**DECISION, CONDITIONS, FINDINGS OF FACT, AND CONCLUSIONARY FINDINGS OF THE  
MCMINNVILLE HISTORIC LANDMARKS COMMITTEE FOR APPROVAL OF A NEW BUILDING AT  
1025 NE 1<sup>ST</sup> STREET WITHIN THE DOWNTOWN DESIGN AREA**

- DOCKET:** DDR 1-19 (Downtown Design Review)
- REQUEST:** The applicant has submitted a Downtown Design Review application to request the approval of the exterior design of a proposed new apartment building to be constructed on a property located within the Downtown Design area.

- LOCATION:** The subject site is located 1025 NE 1<sup>st</sup> Street, and is more specifically described as Lots 5, 6, 7, and 8, Rowland's Addition. The subject site is also identified as Tax Lot 7900, Section 21BD, T. 4 S., R. 4 W., W.M.

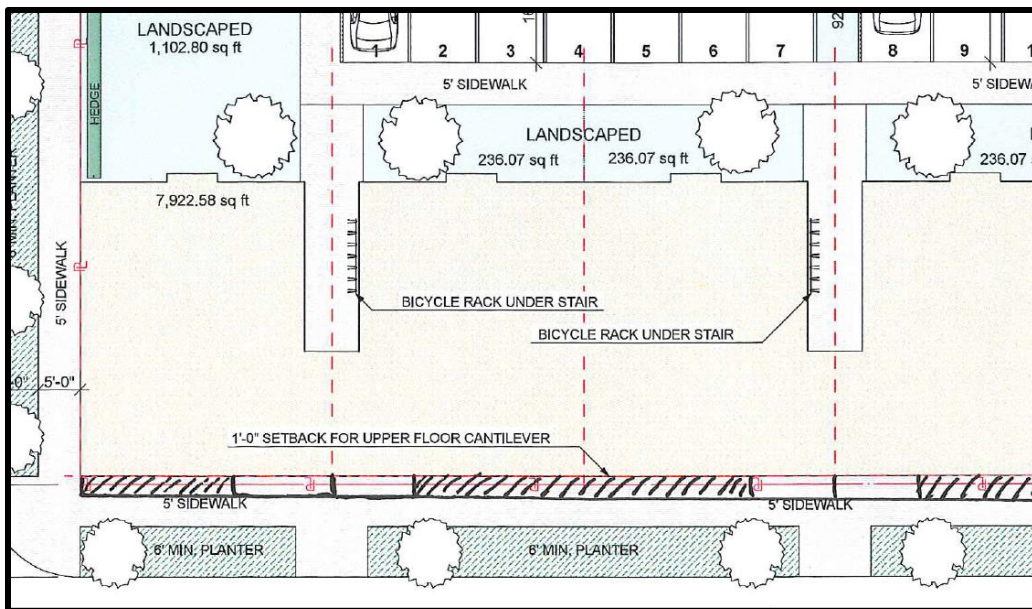
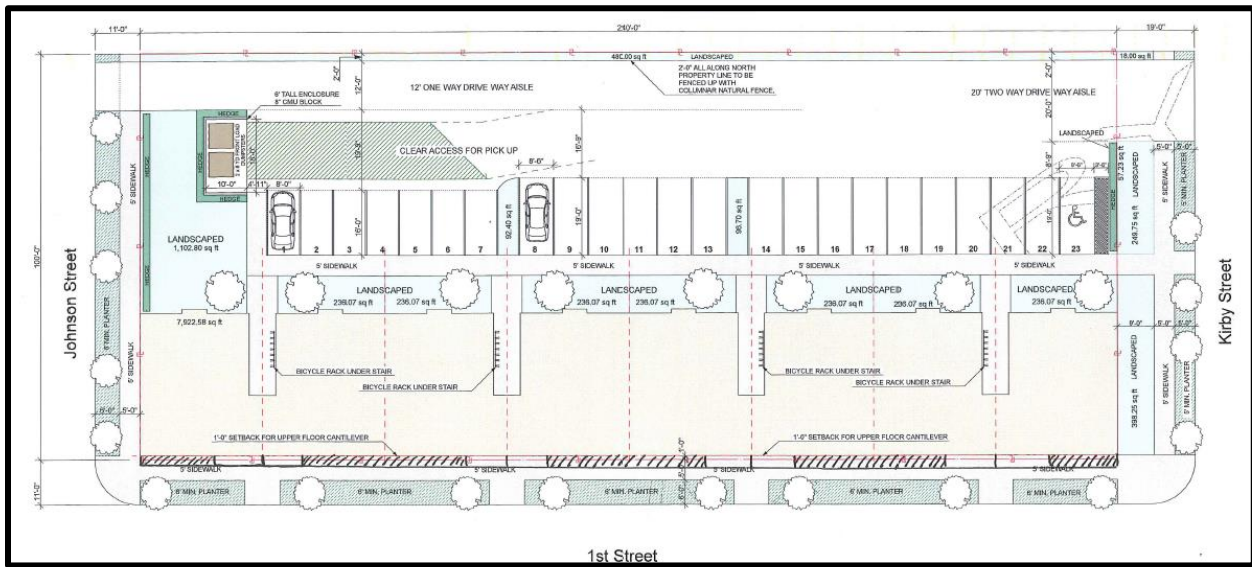
Based on the proposed design, the space being provided for the courtyards is not adequate or large enough to warrant the setback from the property line. The space is only 3 feet deep by 8 feet 9 inches wide, but over 3 feet of that width will be required to be kept clear to allow for the door to swing open into the courtyard space. This does not leave adequate room for the courtyard space to be usable as a courtyard or for dining space as stated by the applicant. The plans also include a “L” shape to the courtyard railing, which would extend out one foot into the one foot setback area. The remainder of the one foot setback area would be paved up to the building wall, which would essentially function as a 6 foot sidewalk in those spaces between courtyards. This railing configuration creates a less than desirable transition between the patio and the sidewalk, and could also present a tripping or safety issue for the public traveling along the sidewalk. The courtyard space as proposed can be seen below:

As stated above, the Historic Landmarks Committee finds that an exception to the zero setback could be provided based on the size of the subject site and the proposed building encompassing an entire block frontage, but that would be only if an adequate space is actually being provided for a courtyard that is more usable for the future tenants. Therefore, a condition of approval is included to slightly increase the setback to allow for a more functional and usable courtyard space that could better accommodate sitting space or dining space.

An example of what is required by the condition of approval can be seen below. The drawing is not to scale, but represents the general design described above. The solid black lines with open space within them represent the fence that would enclose the courtyard, and the dashed areas represent would could be landscaping space between each courtyard. Entry gates could be provided to each courtyard, which

Within the three (3) foot setback area, the construction plans shall be revised to include a fully fenced courtyard in front of the openings in the façade for the ground floor unit entrances. The fenced courtyard shall extend outward from the building wall up to the property line, forming a space that is a minimum of three (3) feet deep and eight (8) feet, nine (9) inches wide, that would be combined with the courtyard space under the upper story balconies. The fenced courtyard may be extended in width along the south façade of the building, if the applicant wished to have a wider courtyard space. The applicant may include gates that lock and either swing open into the courtyard or swing open off the side of the fenced courtyard into the three (3) foot setback area, based on building code requirements.

The three (3) foot setback area between fenced courtyards shall be landscaped, forming a landscape planter area between the building wall and the sidewalk within the NE 1<sup>st</sup> Street right-of-way.

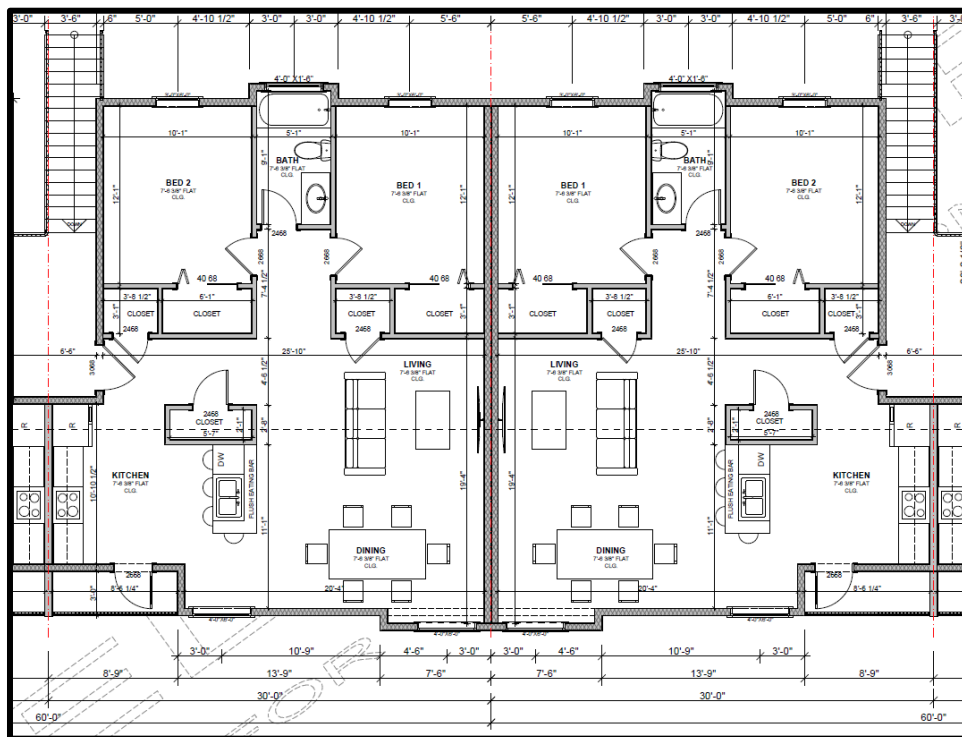
The applicant has stated that the required proportional bays are being created in the front façade by the openings in the front façade for the courtyard and balconies on the lower and upper story apartment units. These openings occur at four points along the front façade, with no more than about 43 feet between the courtyard/balcony openings. In addition to those openings, the applicant is proposing to include vertical reveal joints between stucco paneling to provide for additional vertical division and detailing along each building façade. The application narrative notes that a similar design treatment was approved for the Atticus Hotel building, and the proposed vertical reveal joints will be the same width as was applied on the Atticus Hotel building at 4 feet. Finally, the front façade is also proposed to include architectural projections along the upper story in two locations. These architectural projections are in the form of a one foot bump out, at 15 feet in width, in the area of the dining rooms on the interior of the building. The projections will again only occur on the upper story of the front façade, so the ground floor would be one flush and continuous wall (outside of the openings for the courtyard spaces). These architectural projections can be seen in the floor plan and the renderings below:

The proposed design does include a wider space along the center of the south (front) façade. That space is currently shown as one flat wall, approximately 43 feet in length, between two openings for courtyards and balconies. In order to provide for a more consistent pattern and rhythm along the south façade, and to ensure that the vertical divisions and detailing are being provided along the entirety of the south façade, a condition of approval is included to require that one additional architectural projection, identical in size and design the two included in the proposed design, be provided in the center of the south building façade. The condition specifies that this third architectural projection would extend outward from the dining room spaces within the two most interior apartment units on the upper story of the building. The location of this required third architectural projection can be seen below:

3. That the construction plans shall be revised to include a third upper story architectural projection, identical in size and design to the two (2) included in the proposed design. This third upper story architectural projection shall be located in the center of the south building façade, extending outward from the dining room spaces within the two most interior apartment units on the upper story of the building.

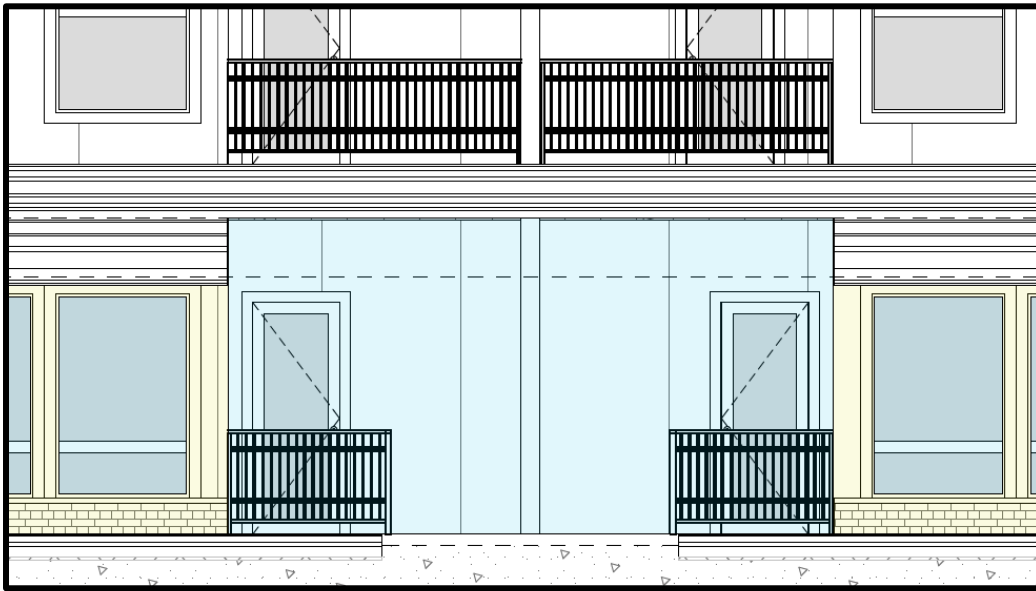
The applicant has proposed a building design that incorporates most of the required storefront features. The building includes a painted fiber cement belt course between the upper story and the ground floor of all building facades that front onto public right-of-way. A similar painted fiber cement cornice is proposed at the roofline along all four building facades to provide the required decorative cornice along the roofline. The beltcourse size and scale as proposed is found to dominate the facades of the building and to detract from the visual purpose of the beltcourse, which is to separate the upper story from the first floor. Therefore, a condition of approval is included to require that the beltcourse proposed to be horizontal along all four building façades be reduced in height to only the height that will run consistently along the façades through the space between the upper story balconies and the ground floor courtyard space openings in the south façade. The condition of approval also states that the remaining façade beneath the beltcourse will be finished with the same building material as proposed for the remainder of the ground floor façade.

A brick bulkhead is proposed at the street level of all building facades that front onto public right-of-way, from grade up to the bottom of the windows along the ground floor façade. The applicant provided detailed calculations for how the 70 percent minimum glazing and 40 percent minimum glazing is being satisfied on the ground and upper floors, respectively. More specifically, 71 percent of the building's ground floor façade and 51 percent of the building upper story façade are proposed to be glazing, between all of the windows and the openings in the façade for the courtyard and balcony spaces. The ground floor apartment units include entryways that are recessed under the balcony spaces above. These entryways include what is described in the application narrative as "transom with a transparent front door", and those transparent doors are identified in the front elevation. However, an obvious transom is not visible in the renderings on these entry doors. A typical trim around the door is identified in the elevation, which can be seen below:

A condition of approval is required that the final construction plans be revised to include a more defined transom on the ground floor apartment unit entrances that open onto the NE 1<sup>st</sup> Street right-of-way.

4. That the construction plans shall be revised to include a more defined transom on the ground floor apartment unit entrances that open onto the NE 1<sup>st</sup> Street right-of-way.

5. That the construction plans shall be revised to allow for the beltcourse proposed to be horizontal along all four building façades to be reduced in height to the height that will run consistently along the façades through the space between the upper story balconies and the ground floor courtyard space openings in the south façade. The remaining façade beneath the beltcourse shall be the same building material as proposed for the remainder of the ground floor façade.
